RE: ADDITIONAL INFORMATION REQUESTED FOR THE MOORE  
RANCH IN SITU URANIUM RECOVERY PROJECT LICENSE  
APPLICATION (TAC JU011), FIRST SET OF RESPONSES

URANIUM ONE AMERICAS  
MOORE RANCH URANIUM PROJECT  
RESPONSE TO REQUEST FOR ADDITIONAL INFORMATION  
TECHNICAL REPORT REVISION INDEX

**FIGURE 2.2a-1**

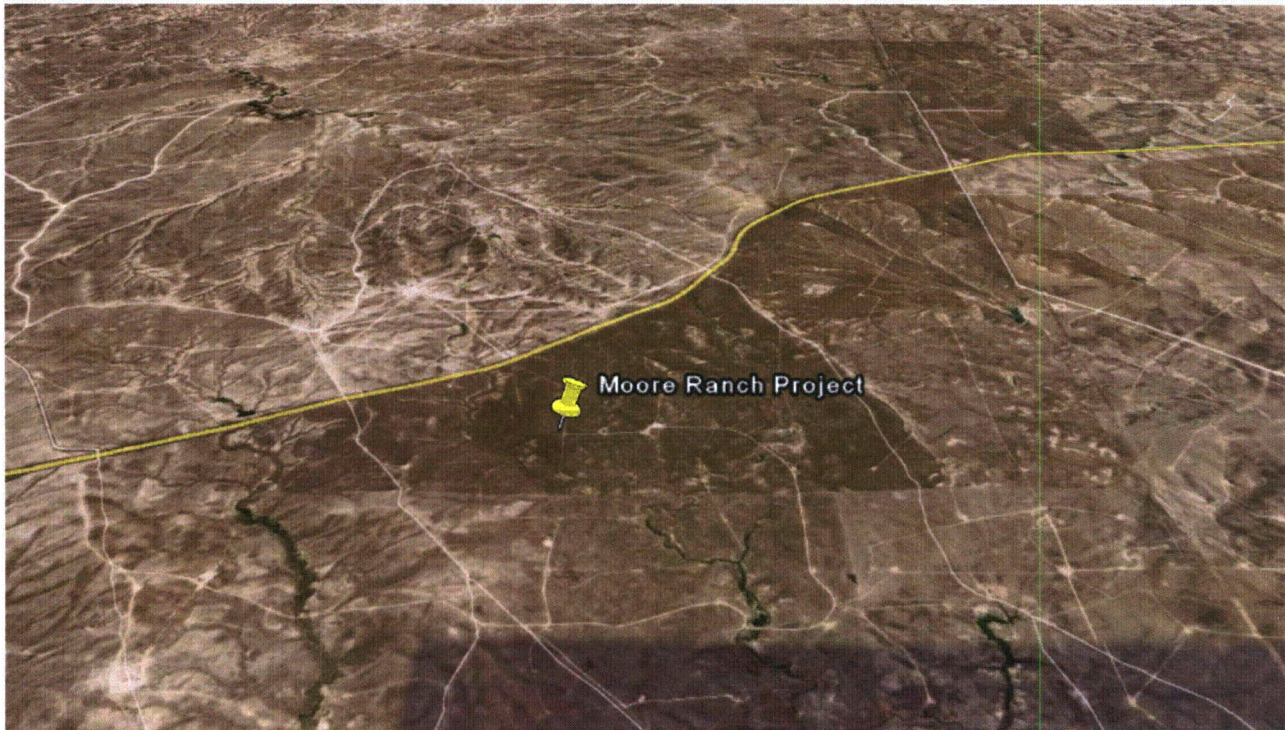
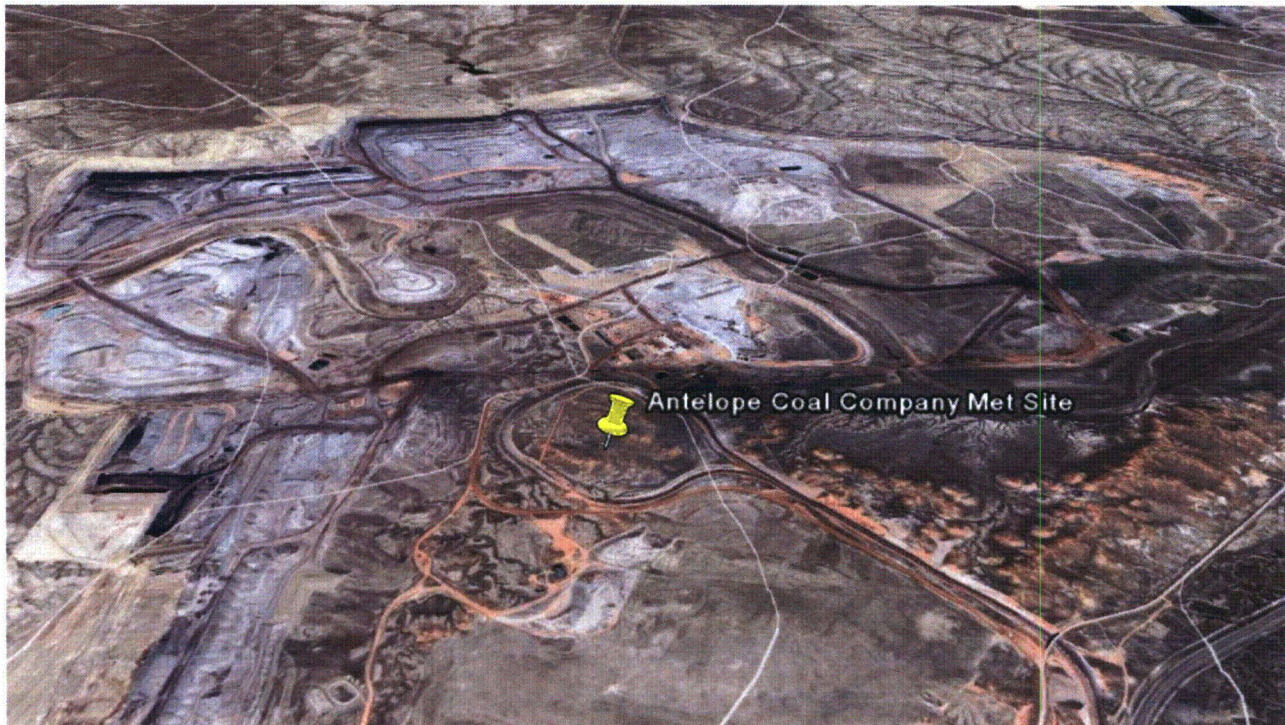
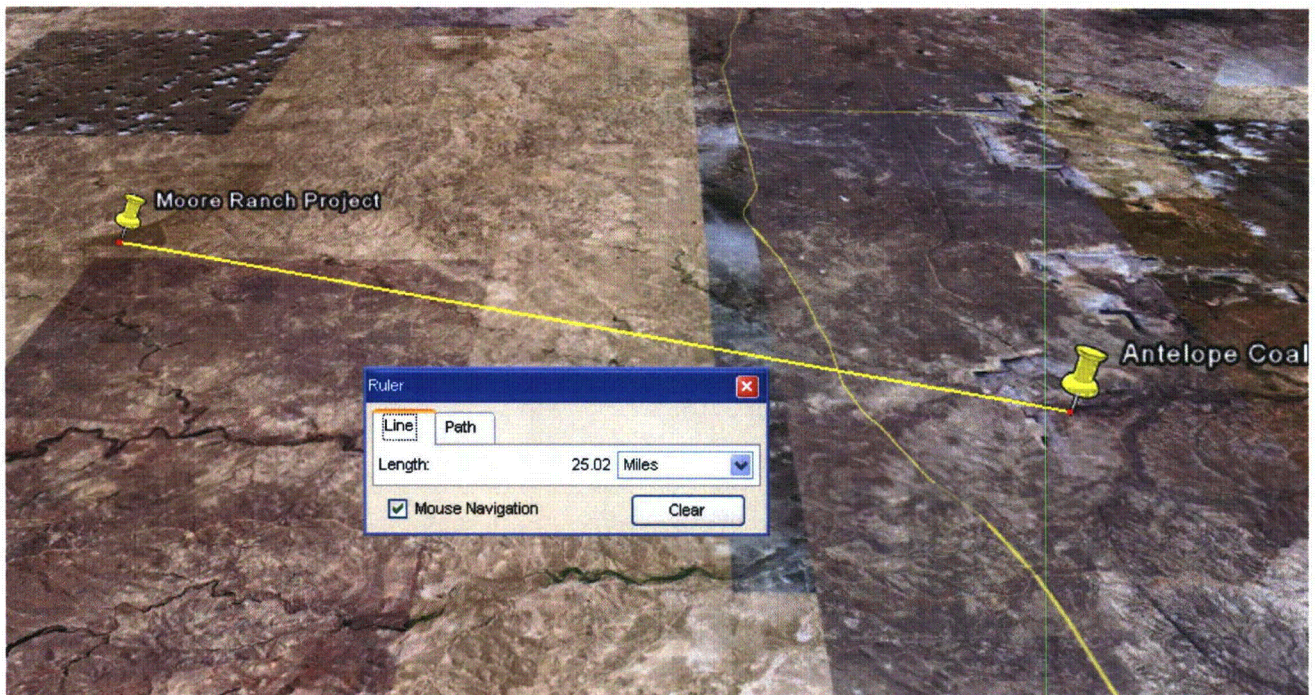
- a. The applicant indicated that no onsite meteorological data was collected at the Moore Ranch site but instead, used meteorological data collected from Antelope Coal (ACC) and Glenrock Coal (GCC) to represent the Moore Ranch site. However, the applicant has not discussed its basis to assume that the data can be used to represent the Moore Ranch site without any data from the Moore Ranch site. Therefore, provide the justification to use the data from these two sites (ACC and GCC), without onsite meteorological data, to represent the Moore Ranch site.

As stated in the conclusion of the Climatology Report, the Antelope Mine (ACC) meteorology most nearly represents that of the Moore Ranch project site, and is therefore proposed as the source of meteorological data to be substituted for on-site monitoring. Data from the Glenrock Mine (GCC) was intended only to supplement ACC and to support the general conclusions made regarding local meteorology. To illustrate the similarities between Moore Ranch and ACC, several images from Google Earth are presented below. Figure 2.2a-1 shows an aerial view of the Moore Ranch area, and Figure 2.2a-2 shows a similar view of the ACC site (with meteorological station pinpointed). The ACC site has similar topographic features (Figure 2.2a-3) and is about 25 miles from the project site (Figure 2.2a-4). Both sites are characterized by mildly rolling hills covered with grass and sparse shrubs. The nearest mountain ranges are:

Due to these large distances, neither the ACC site nor the Moore Ranch site experiences significant wind channeling or shielding from any of the three mountain ranges. Also, there are no major bodies of water affecting the meteorology of these two sites. The ACC site is several hundred feet lower in elevation than Moore Ranch. Both, however, are situated on the southeasterly side of the hydrologic divide with a similar vertical relationship to the divide.

Section 2.5 of the application was revised to include the above information.

FIGURE 5.7-1

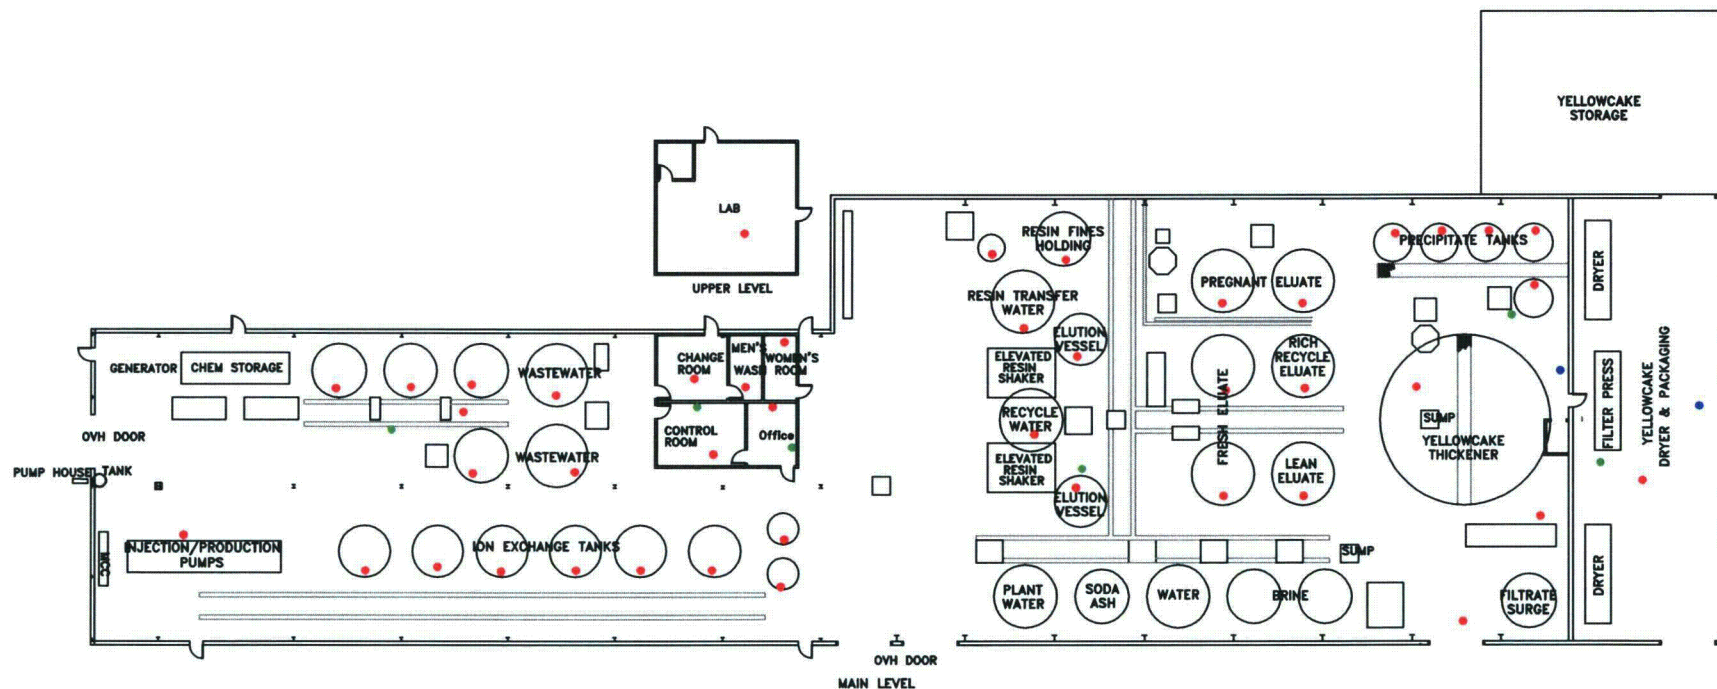
a. The location of airborne particulate and radon daughter sampling are depicted in Figure 5.7-1 of the technical report. However, according to Figure 5.7-1, no airborne particulate monitoring will be performed in the control/lunch room or the ion exchange area. Explain why airborne particulate monitoring is not necessary in the control/lunch room and ion exchange area.

**Figure 5.7-2**

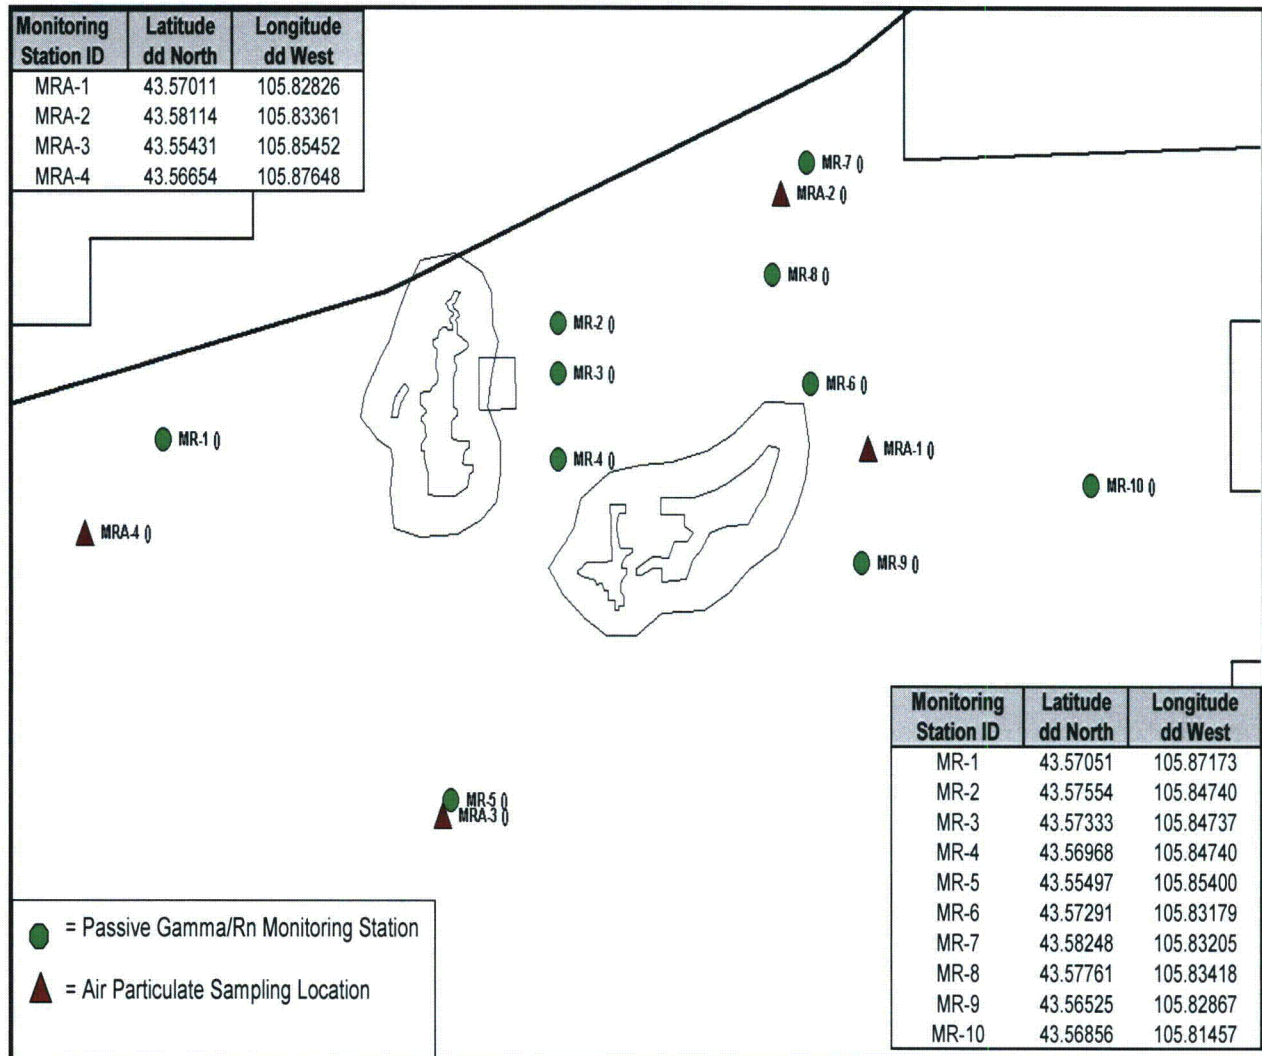
- a. Regulatory Guide 4.14 states that for air, radon monitoring should be conducted at five or more locations and these locations should be the same locations as for air particulate monitoring. From Figure 5.7-2, it does not appear that all of the air particulates (triangle symbols) are the same location as the radon monitoring. Please demonstrate that at least five air particulate monitoring locations are within the same proximity as the radon monitoring locations. Also, identify in Figure 5.7-2, which location is the control location.

The control/background air particulate and radon monitoring stations are represented by ID numbers MRA-4 and MR-1 (as respectively shown in Fig. 2.9-25 and 5.7-2). Again, these locations are generally upwind of the plant location based on annual prevailing wind directions presented in the earlier response to comment 2.10 (d).

Operational radon monitoring will be accomplished at the four air particulate stations as recommended in Regulatory Guide 4.14. The control/background air monitoring station will be represented by station number MRA-4 as shown in Fig. 5.7-2. This location is at least one mile west/southwest (i.e., upwind) of the plant location and wellfield areas.
